MEMORANDUM

SUBJECT: **MANDATORY REFERRAL** No. 01007-SHA-1—State Highway
Administration (SHA) Congestion Relief Study—Intersection
Improvements—**New Hampshire Avenue (MD 650) at
Olney—Sandy Spring Road (MD 108)**

RE: Intersection Improvements for
MD 650 (New Hampshire Avenue)/
MD 108 (Olney-Sandy Spring Road)

SUBJECT: MD 108/ MD 650 Intersection Improvements

M23 MD 108 (Old Spring Rd) / MD 650 (New Hampshire Ave) / MD 650 (New Hampshire Ave) / MD 650 (New Hampshire Ave)

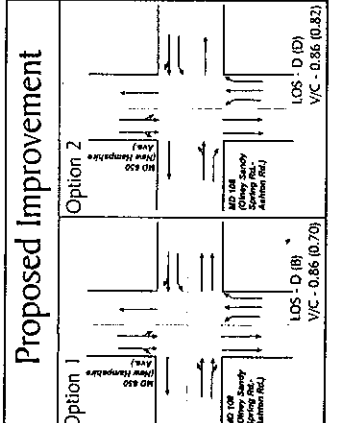
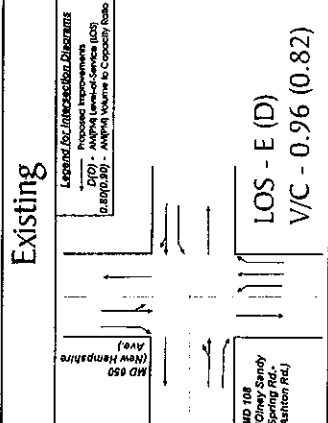
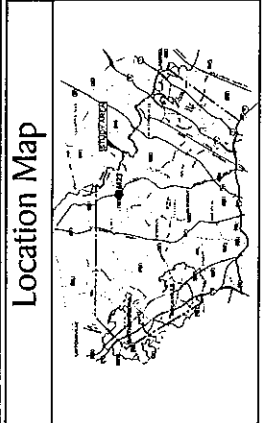
1. All intersections within the limits of this project must be made ADA accessible.
2. Construct a right turn island in the southeast quadrant of the intersection to reduce the pedestrian crossing distance.
3. Extend the proposed bikeway on the west side of MD 650 to Crystal Spring Drive.
4. Construct a bikeway on the north side of MD 108 from the intersection to the Sherwood High School crossing signal.
5. Maintain the existing open section roadway, east of the bank on MD 108. The proposed sidewalk is not required along the open section roadway.

The proposed improvement design incorporates closed-section design (curb and sidewalk) throughout, which is consistent with the existing conditions at the intersection. However, staff recommends that the closed-section design on MD 108, east of the intersection, transition to open section, without sidewalk, at the east edge of the bank property. This change will better preserve the area's rural character.

The project includes development of a sidewalk along the south side of MD 108, and the master planned bikeway and a sidewalk along the south leg of MD 650, east and west sides respectively. Staff recommends extending the bikeway on MD 650, south to Crystal Spring Drive. The new eastbound curb lane of MD 108 should be 16 feet wide to accommodate bicyclists who prefer to use the roadway.

In addition to these improvements staff recommends that a bikeway be added on the north side of MD 108 from the intersection west to the Sherwood High School crossing signal. As outlined in the second page of the attached memo, Community-based Planning staff believes the bikeway should be located on the south side of MD 108. However, Transportation Planning and the Department of Public Works and Transportation (DPWT) staff recommend a north side location. The north side is recommended due to the lack of space to implement it on the south side.

At the MD 650/MD 108 intersection, a right turn island in the southeast quadrant would be desirable, to shorten pedestrian crossing distances. All intersections within the project limits must be made ADA accessible.

The landscape plans are not typically detailed until the final design stage. When they are prepared, they will be coordinated with staff. Three mature trees are at risk in the southeast quadrant. The removal and/or impact of large trees must be mitigated with preservation measures and replacement trees. In particular, staff suggests tree removal mitigation at this intersection consist of a minimum 2½ to 3 inch caliper shade trees in double rows within the right-of-way or on private property with the owner's permission.
